Network Rail (London North West Territory)

Support for Listed Building Consent

Structure Name:	<i>Bridge 42</i>	Structure Number:	<i>42</i>
ELR:	<i>BEJ</i>	Mileage:	<i>10m 0462yds</i>
Structure Type:	<i>Underbridge</i>	OS Ref:	<i>SP 105 775</i>
Location:	<i>Whaley Bridge, Derbyshire</i>		
Report Ref:	<i>R2200-P7F98-LBC-04</i>	Revision:	<i>-</i>

SUPPORT FOR LISTED BUILDING CONSENT

**Figure 2** – Cross section through existing deck  
Illustration of how construction space for new structural members is limited

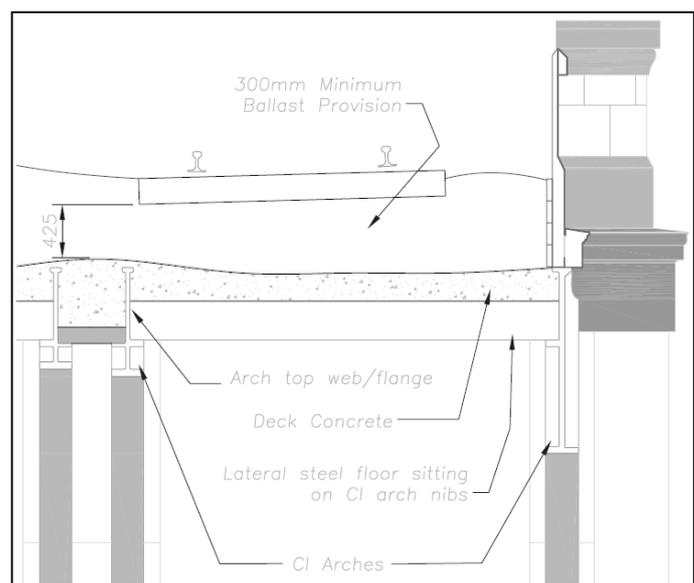
*"The applicant has failed to explore solutions in which realistic loadings might be accommodated through repair and strengthening of the existing fabric."*

- i. Existing Bridge Form of Construction  
The lateral steel/concrete floor, which spans between nibs of the CI arches, is at the same level as the arch top web/flange and thereby occupies the construction space available – refer to Figure 2 below.

The current track alignment can accommodate only increases of structural depth of approximately 125mm, with a strengthening solution to the top of the deck. Achieving capacity through strengthening in this available space is therefore considered to be impractical, without vertical realignment of the track.
